PROJECT: ADDENDUM NO.: 1

Willow Lake School Addition

OWNER: DATE OF ISSUANCE: Willow Lake School District 12-3 February 10, 2023

CO-OP Architecture

ROOF FRAMING PLAN - AREA C

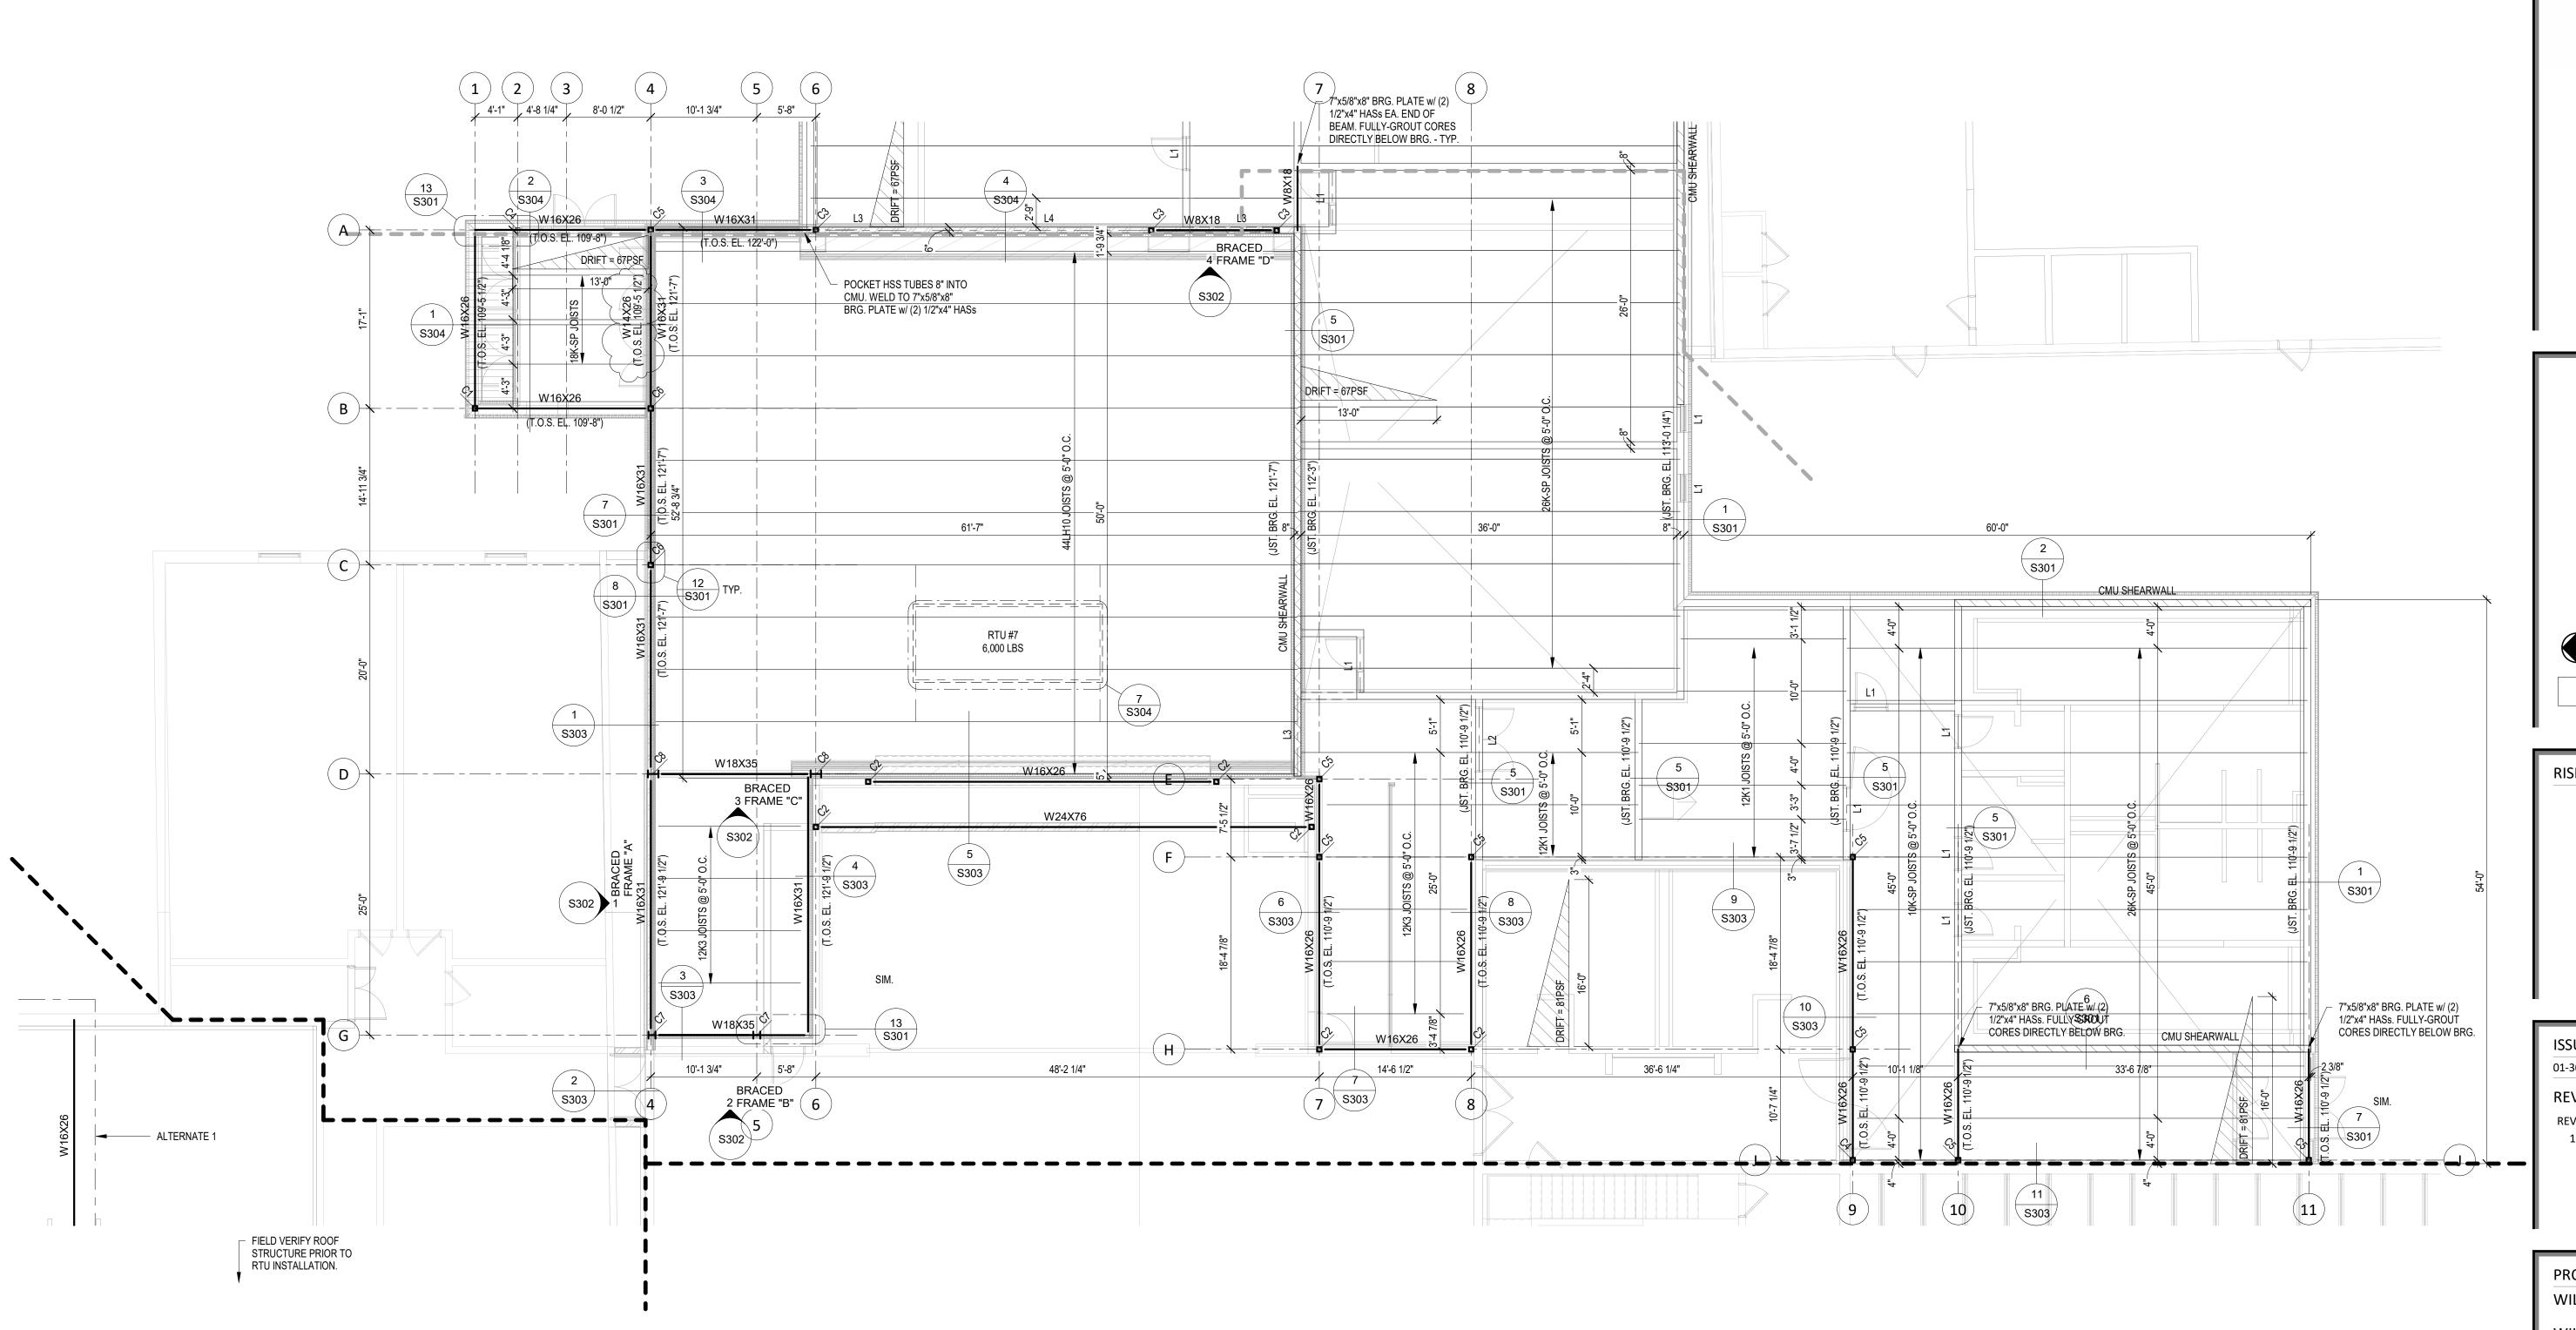
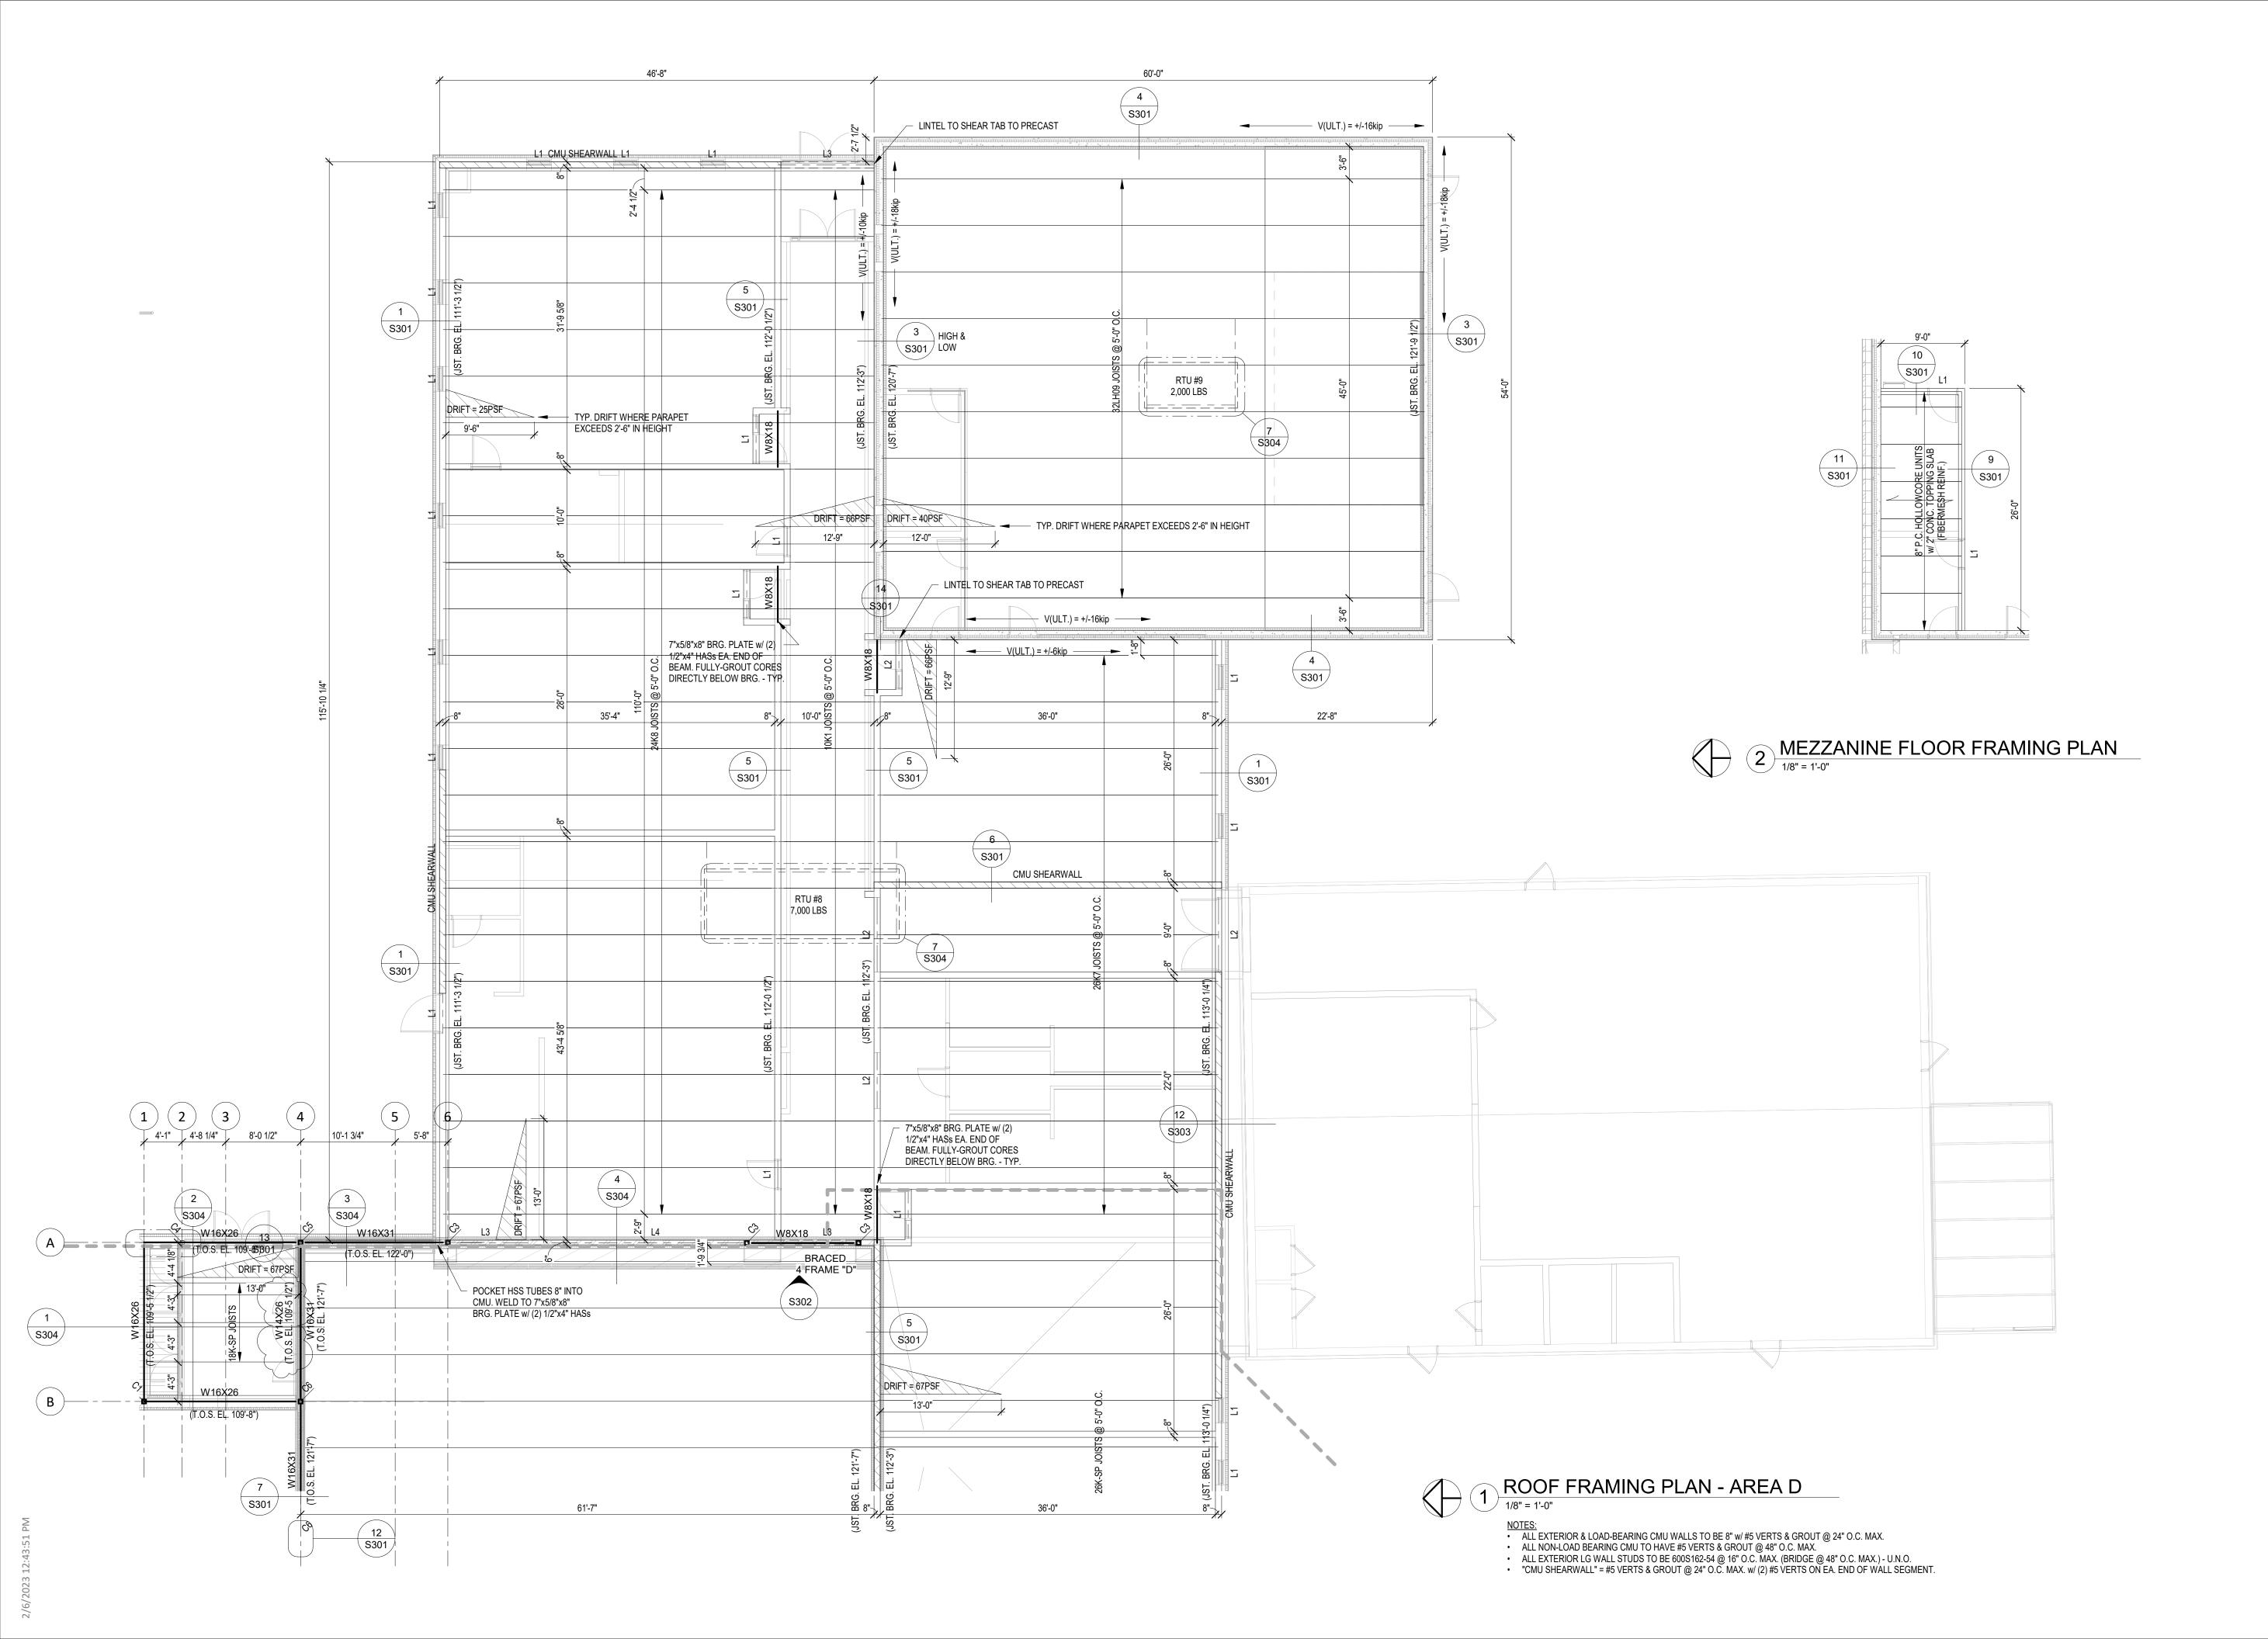
- 3) Sheet S200C ROOF FRAMING PLAN AREA 'C'
 - a. See clouded areas for revisions.
- 4) Sheet S200D ROOF FRAMING PLAN AREA 'C'
 - a. See clouded areas for revisions.

PHASING PLAN

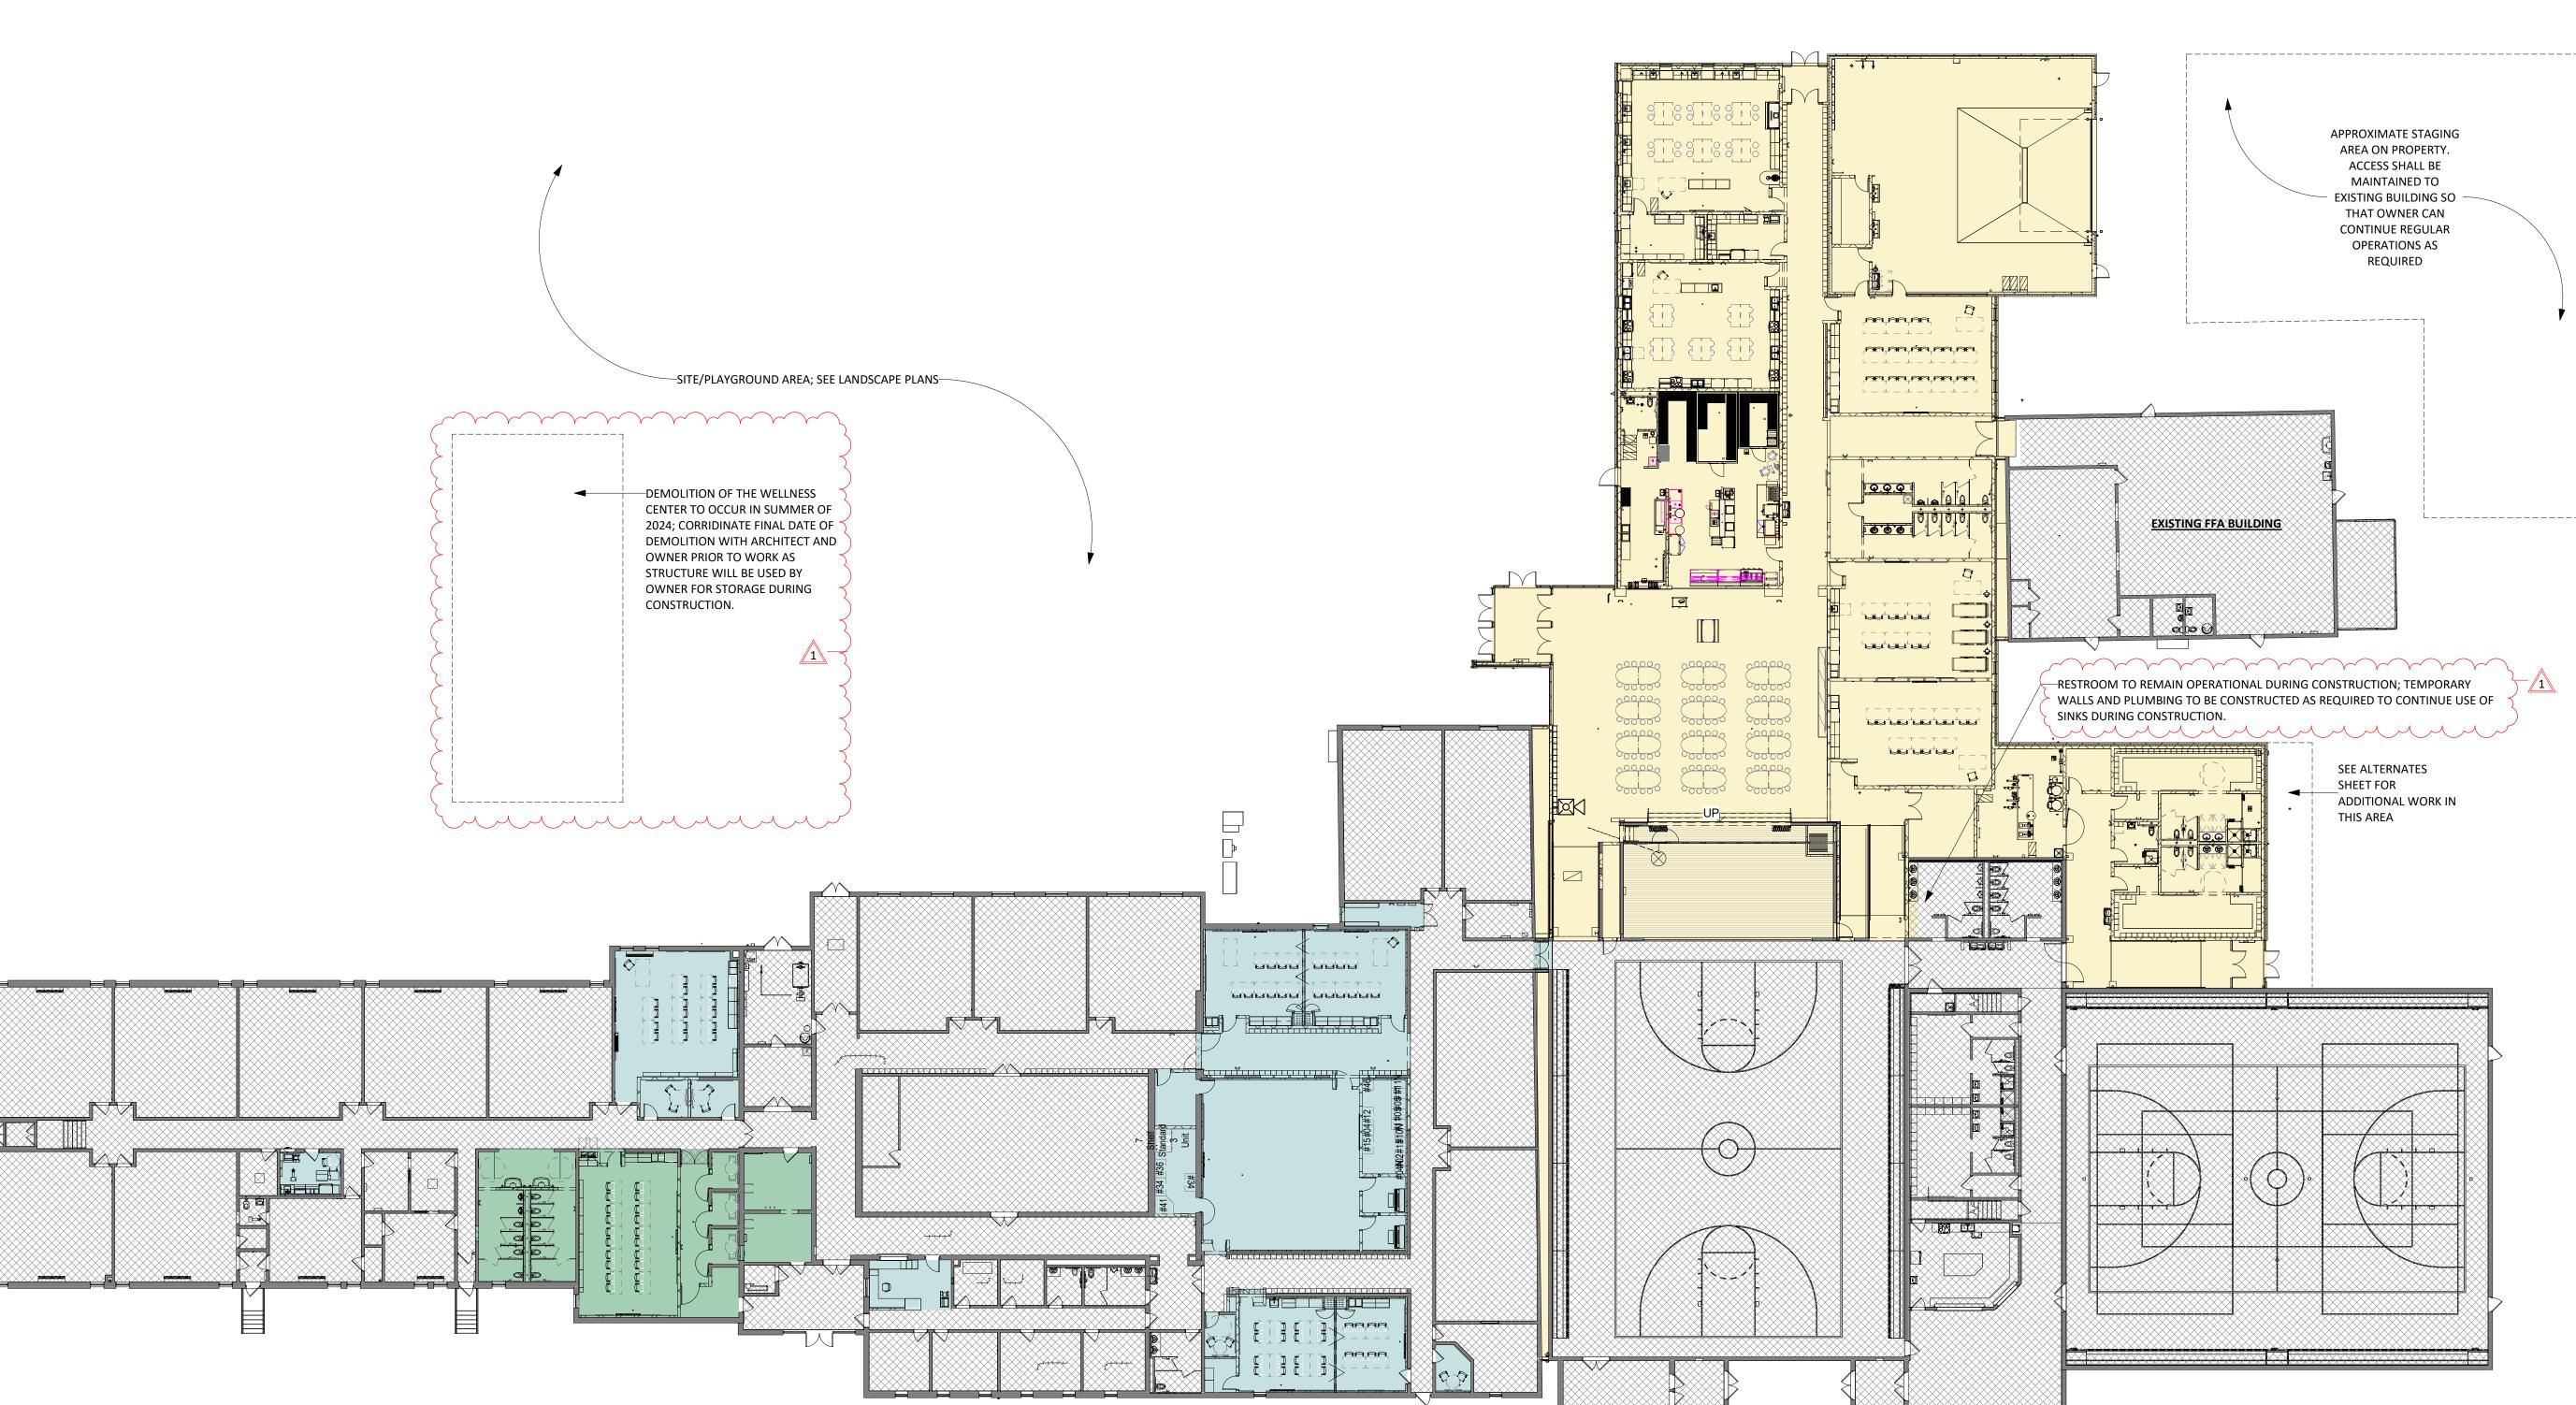
- 1) Sheet G003 TYPICAL ASSEMBLIES & GENERAL NOTES
 - a. Revised name of Floor type F2 for clarity.
- Sheet G004 PHASING PLAN
 - a. Revised phasing of existing Wellness Center structure and added clarifying note for existing restroom function during construction.
